# Access Compliance Report

## Public Rights-of-Way

### (Curb Ramps)

Intersection ID: 11933	Main Street: W_8TH_ST	Cross Street: N_TRYON_ST	Location: W
ADA ID: DF65B5540328	Ramp Type: PerpDiag	Initial Pass/Fail: Fail	Overall Compliance: No
Severity Score: 8.75			
Codes/Mitigation Info/Possible Solution		Field Measurements/Component Compliance

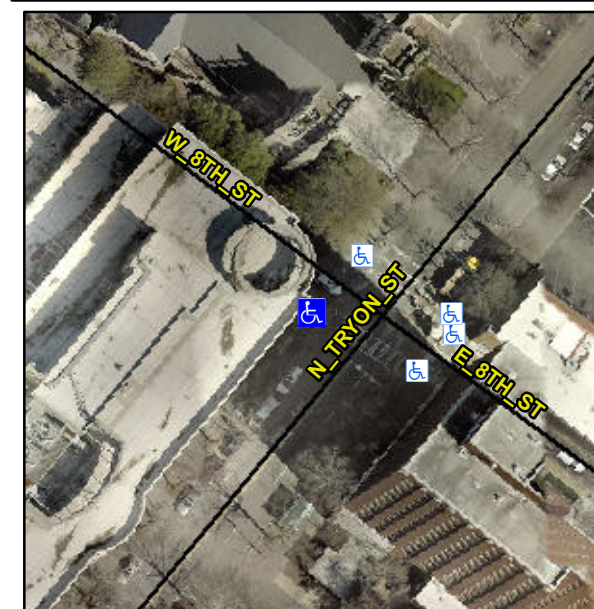
**Not Found, R304.5.1**

Compliance	Description	Data	Compliance	Description	Data
N/A	Ramp Length (in)	96.0	Yes	Ramp Slope (%)	6.2
No	Ramp Width (in)	46.0	Yes	Ramp XSlope (%)	1.9
N/A	Flare Type LT	N/A	N/A	Flare Type RT	N/A
N/A	Flare Slope LT (%)	N/A	N/A	Flare Slope RT (%)	N/A
N/A	Flare Traversable LT?	N/A	N/A	Flare Traversable RT?	N/A
N/A	Landing Length (in)	N/A	N/A	DWS Provided?	N/A
N/A	Landing Width (in)	N/A	N/A	DWS Contrast?	N/A
N/A	Landing Slope (%)	N/A	N/A	DWS Length (in)	N/A
N/A	Landing X Slope (%)	N/A	N/A	DWS Full Width?	N/A
N/A	Landing Curb? (Y/N)	N/A	N/A	DWS Offset (in)	N/A
N/A	Shared Landing?	N/A			
N/A	Gutter Ponding?	N/A	N/A	Gutter Slope (%)	N/A
N/A	Gutter Lip Ht (in)	N/A	N/A	Gutter X Slope (%)	N/A
N/A	Painted X Walk1?	Yes	N/A	Painted X Walk2?	Yes
	X Walk 1 Direction	To SE		X Walk 2 Direction	To NE
N/A	X Walk 1 Width (in)	108.0	N/A	X Walk 2 Width (in)	110.0
	X Walk 1 Slope (%)	2.9		X Walk 2 Slope (%)	1.1
	X Walk 1 X Slope (%)	0.9		X Walk 2 X Slope (%)	0.6

**Remove & Replace Curb Ramp With Two New Directional Ramps or Equivalent.**
